### **15 CREMORNE STREET**

Thank you for a copy of the Auckland Council request for further information dated 14 May 2020 regarding the noise from the proposed change of conditions 10 and 12 of a consent relating to the number of permitted helicopter flights from 15 Cremorne Street, Herne Bay. The following sets out the request and our response.

Figure 1. Site 2 (20 Cremorne Street)

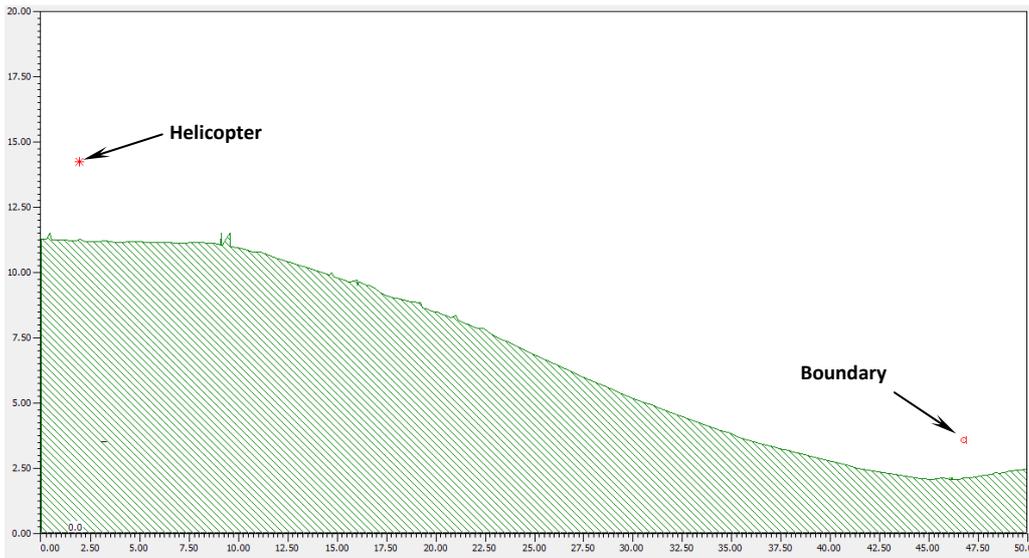
*Please provide predicted  $L_{dn}$  levels at the site boundary of 6 River Terrace and 10 Wairangi Street where written consents were not obtained.*

These two sites are a slightly further from the helipad as predicted for 20 Cremorne Street (Site 2 in the report) so a similar to lower noise level (50dBA  $L_{dn}$ ) could be expected. Figure 1 shows the cross section to Site 2 (20 Cremorne Street), Figure 2 the cross section to 6 River Terrace and Figure 3 the cross section to 10 Wairangi Street. As shown on these cross sections the helicopter noise is located 3m above ground level and the receiver height of 1.5m at the closest site boundary to the helipad and any intervening buildings are include on the cross section.

As shown on Figures 1 – 3 there are screening effects to 6 River Terrace and 10 Wairangi Street when the helicopter is on the ground and at immediate lift off so the level received at these two sites will be slightly lower than for 20 Cremorne Street and within 50dBAL $_{dn}$ .

**Figure 4. Noise trace of Air Bus H130T2**

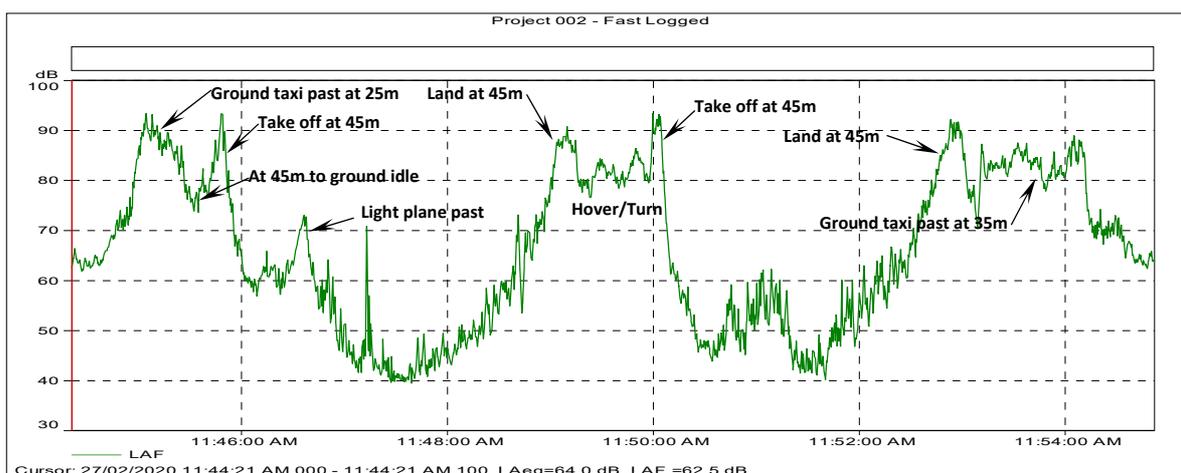
Please provide noise monitoring results from field testing of an Air Bus H130T2 during landing, shut down, start up, ground idling, take-off and hovering (if available).

Figure 4 shows the noise trace undertaken during the testing.
